# Technical Note

**Project:** Southern Access Road, Chichester

**Subject:** Additional Highways Information Review

<b>Client:</b>	Chichester City Council	<b>Version:</b>	A
<b>Project No:</b>	06683	<b>Author:</b>	JS
<b>Date:</b>	17/02/2023	<b>Approved:</b>	AL

**Figure 2: A27 East of Fishbourne Roundabout - Westbound**

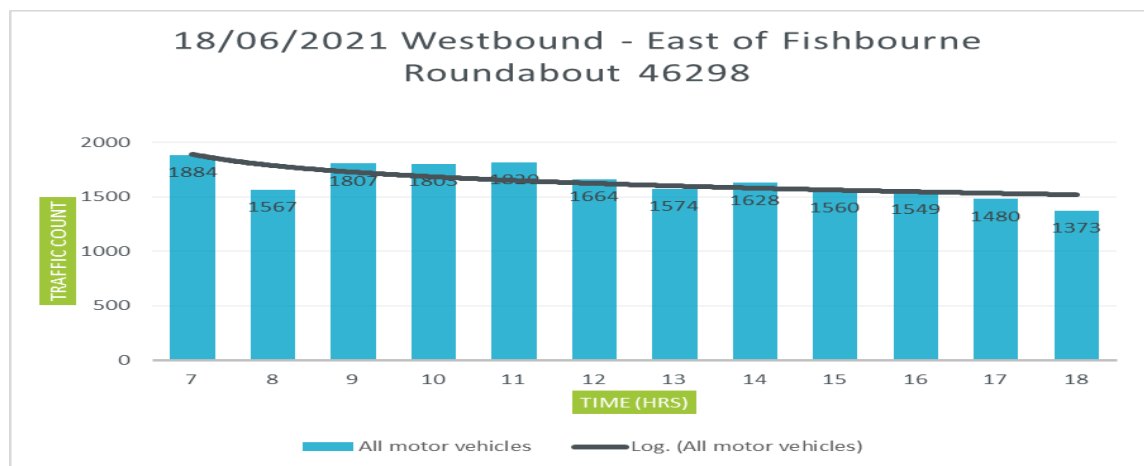
2.3.2 Similar to Figure 1 in the evening, Figure 2 highlights that traffic flows in the 7-8am period are higher than other times indicating traffic is higher before the traditional peak, indeed Figure 2

2.3.3 Figure 2 reveals that traffic in the 8-9am period is lower, suggesting that the congestion in the pre-peak period reduces network capacity.

2.3.7 Figure 2 highlights the build-up of traffic in 7-8am period in Chichester affects network capacity it is important to explore these cumulative effects ahead of the A27 corridor improvement.

2.3.36 It is true that daily and seasonal variations occur and these maybe greater than 5%. The previous report from PJA notes that recent traffic flow counts show the A27 to be operating at capacity. As Figure 2 demonstrates, the existing operation of the A27 is affected by queuing at the Fishbourne roundabout, as such a 5% increase in traffic could reasonably reduce capacity of the SRN further.

**Figure 5: Applicant Diagram – Summary of Transport Impact Assessment Methodology**

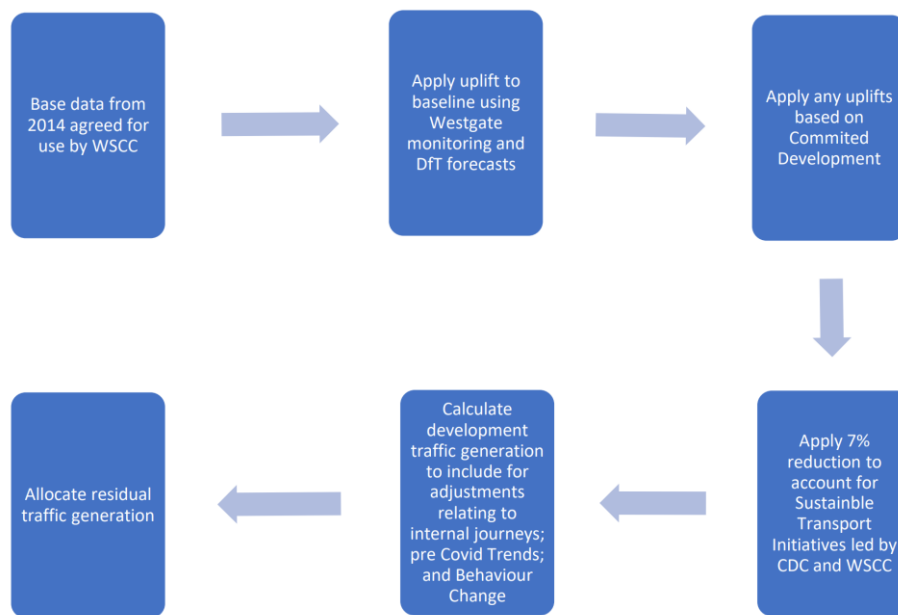
2.3.22 The proposed approach does not consider the requirements for D&P, however on its own could be a reasonable approach had sufficient supporting evidence been provided. Further evidence is required to sufficiently support assumptions made with additional steps included to ensure all effects have been appropriately addressed and that the data is as accurate as possible.

2.3.23 A reduction factor has been applied to baseline trip generation estimates as it has been assumed that policies included within the Local Plan have and will reduce vehicle trips. There may be evidence to support some reduction but this should be presented in the application.

- 2.3.24 Applying a blanket 7% reduction assumes that the policies set out within the Local Transport Plan will be successful and will affect every part of the county equally. This is clearly not the case, and any reductions will be highly dependent on what package of measures would be delivered within the local area.

- 2.3.28 Considering these criticisms, PJA have outlined an alternative methodological approach, in Figure 6, taking into account the requirements to achieve the D&P approach. It is urged that this methodology is followed to ensure the suitability of the proposed development and adequately address the concerns raised by the LHA and NH.
